### Addendum No. M-04

Reference: Added Scope and clarification

Issue Date: November 18, 2024

Project: UHN TWH – SEM & Corridor (EXP Project Number MRK-23004289-A0)

##### **1.1.1. M-003 – SEPARATE PRICE PLAN**

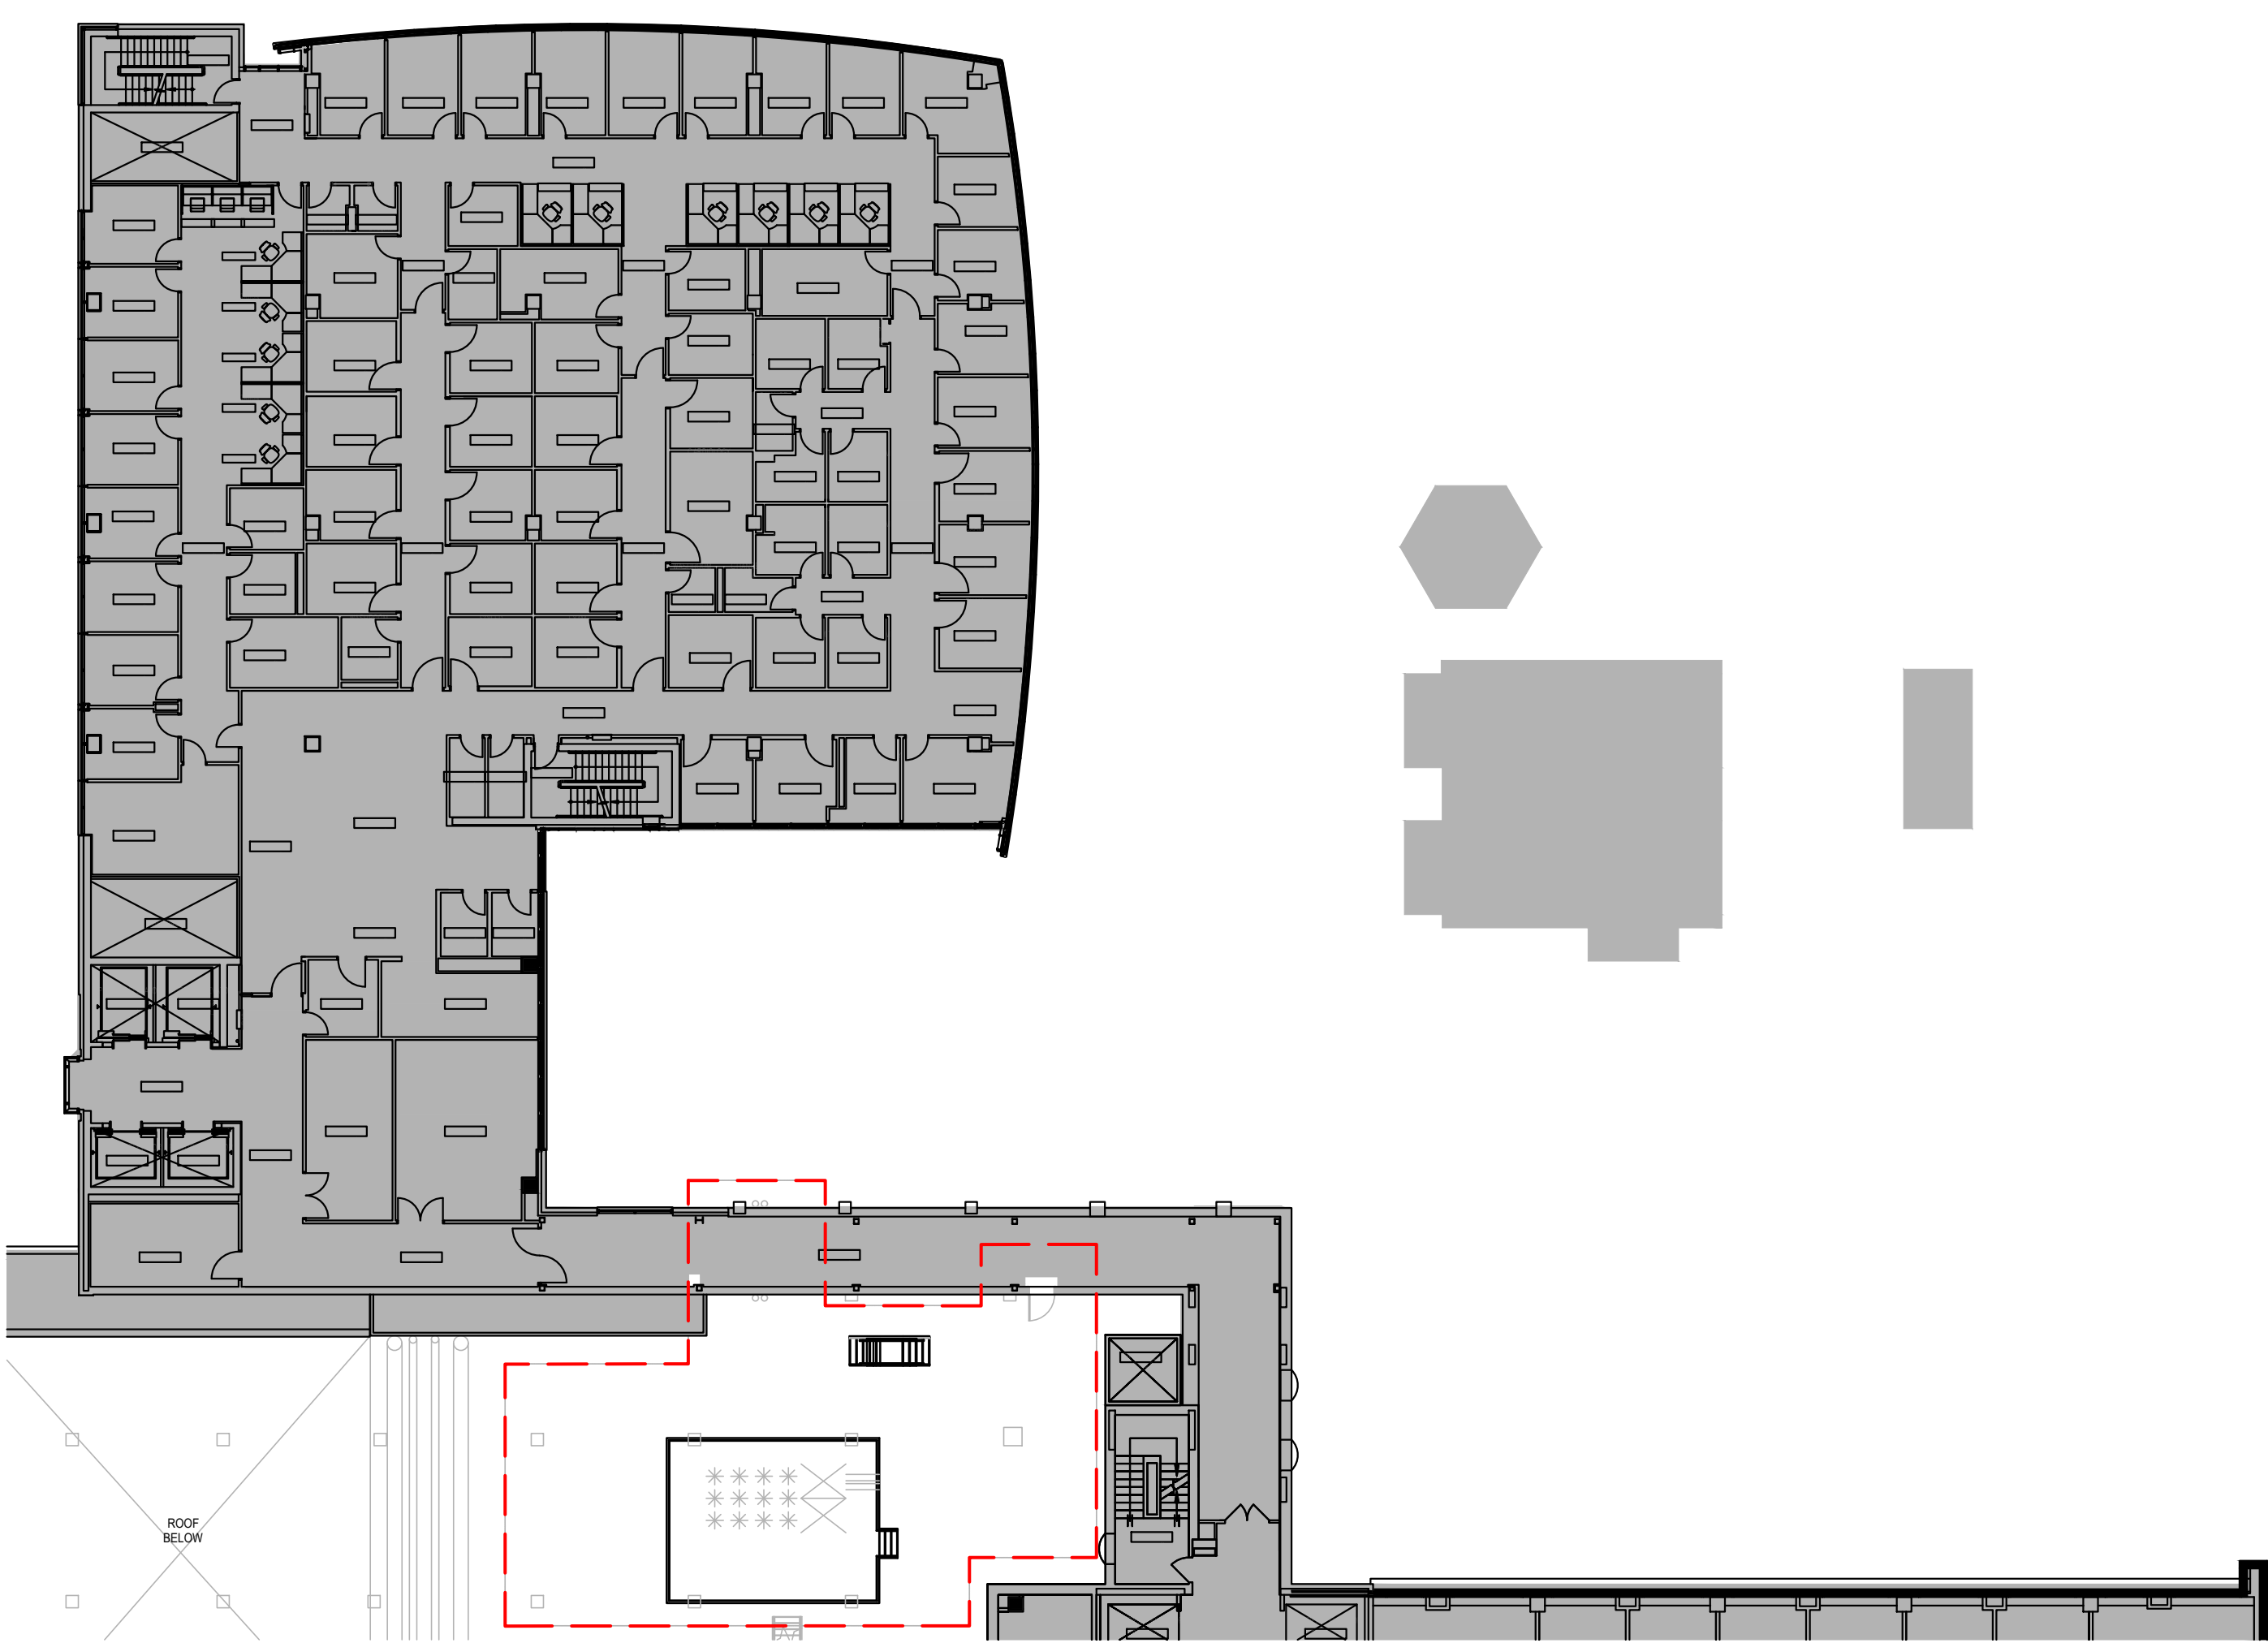
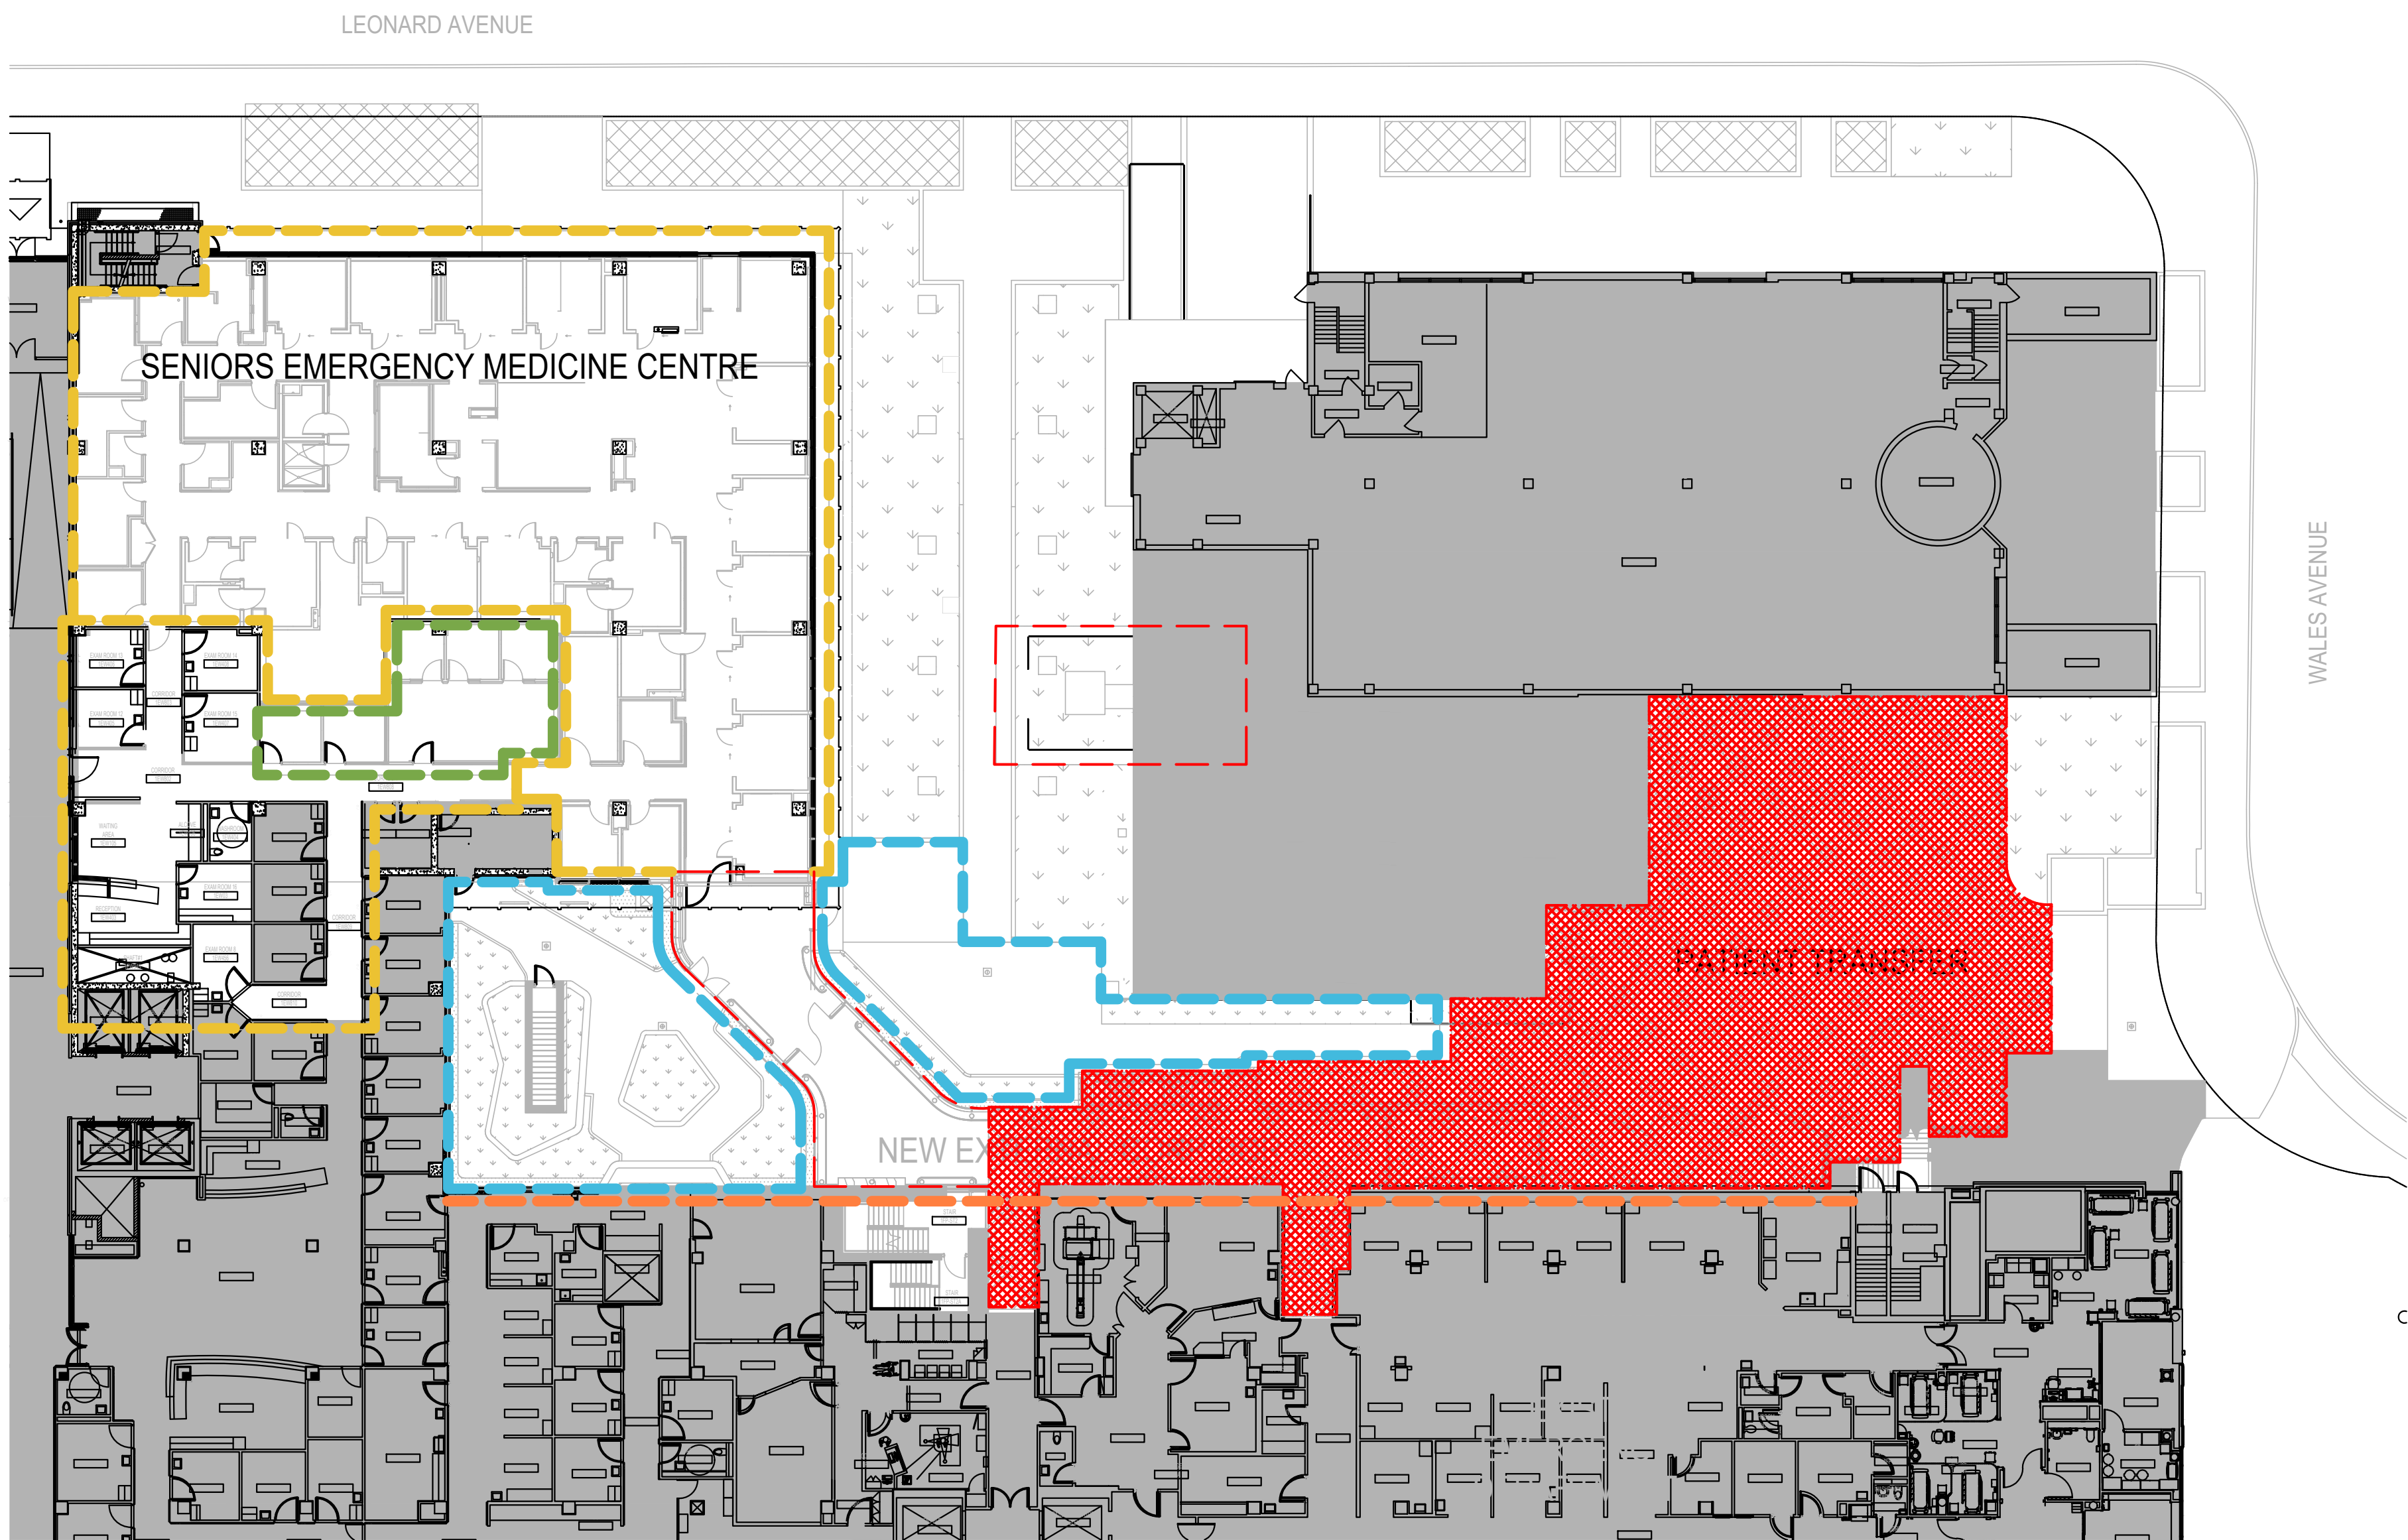
- .1 Updated the arch backgrounds.
